PUBLIC INTEREST REVIEW FOR GROUNDWATER APPLICATIONS

TO: Water Rights Section Date August 21, 2015
 FROM: Groundwater Section Aurora C. Bouchier
Reviewer's Name
 SUBJECT: Application G- 18076 Supersedes review of August 12, 2015
Date of Review(s)

A. GENERAL INFORMATION: Applicant's Name: Meza County: Clackamas

Water-Level Trends in Nearby Wells

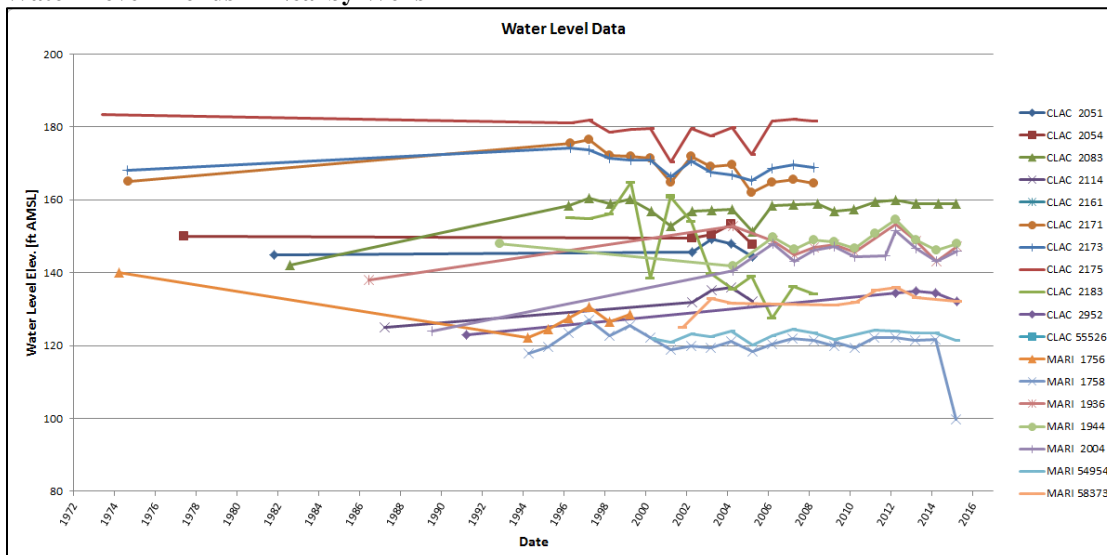
Observation from nearby wells indicate relatively stable long-term trends for alluvial wells in the immediate vicinity of the proposed POA (see attached hydrograph), but increased groundwater development in the area indicates a need for additional water-level monitoring (7N) if this permit is issued. According to the Water Master Joel Plahn (personal communication, 8/12/2015) both Butte Creek and the Pudding River (which Butte Creek is tributary to), are currently regulated. Any additional withdrawals from the streams would be undesirable.

Stream Depletion Results

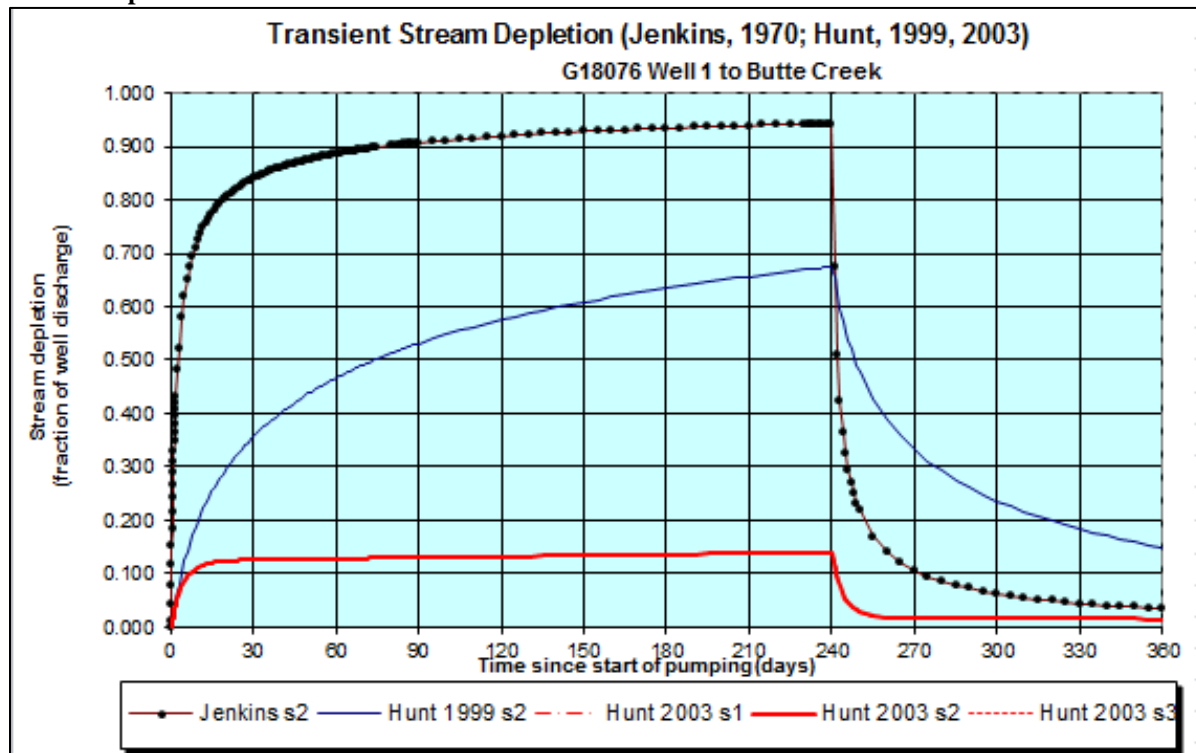
Comments: Stream depletion was estimated using the Hunt 2003 model (see attached results). An aquifer saturated thickness value of 40 feet was used based upon published maps (Gannet and Caldwell, 1998). Butte Creek cuts through the Willamette Silt in this region. Therefore, stream clogging was modeled by using an aquitard thickness below stream value of 3 feet.
